ADDENDUM No. 2

RFP No. 26-17

S Maple, Arbordale St, Sherwood St, and Sherwood Cir Improvements

8" Cla-Val Model 586 Check Valve and Vault

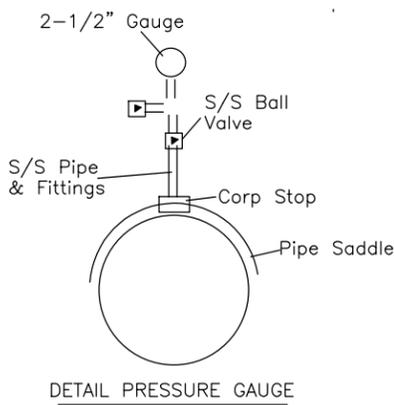
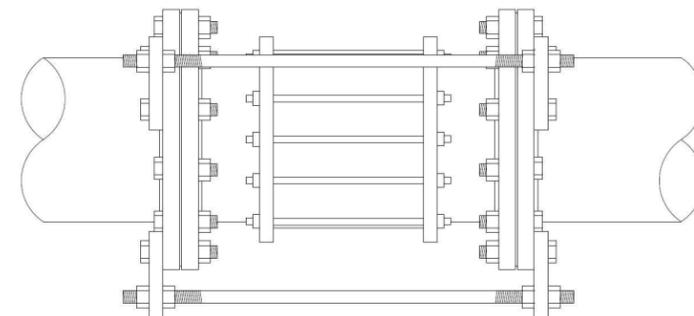
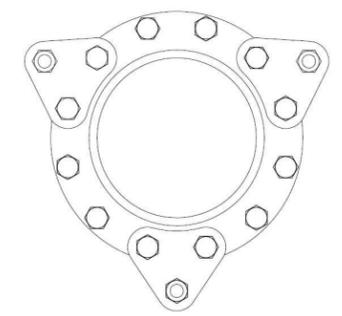
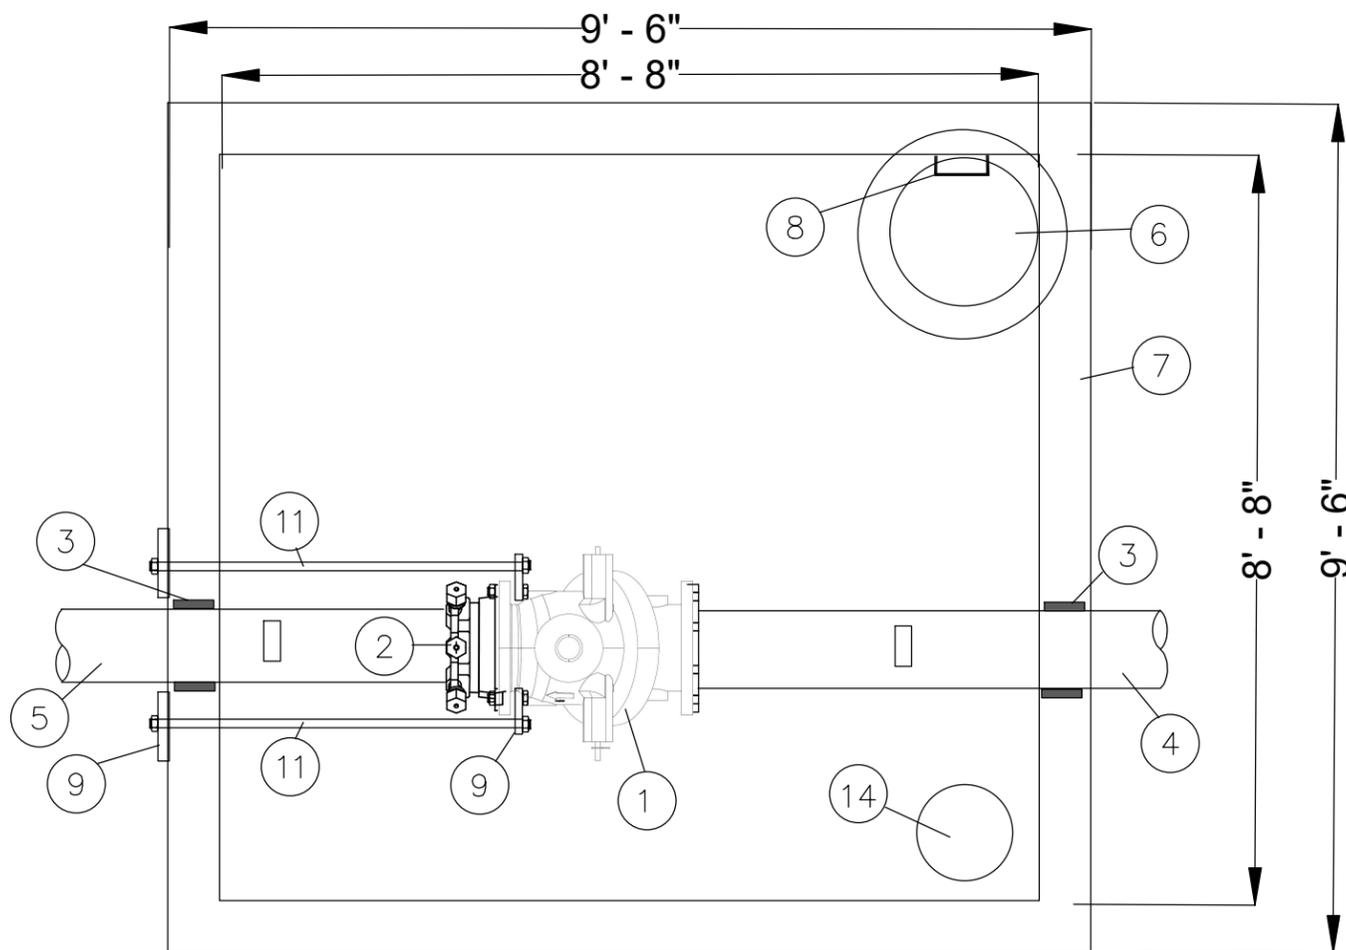
Section/Page(s)	Change
Appendix Addition	8" and 10" Cla-Val Check Valve & Vault Details added as Appendix 2
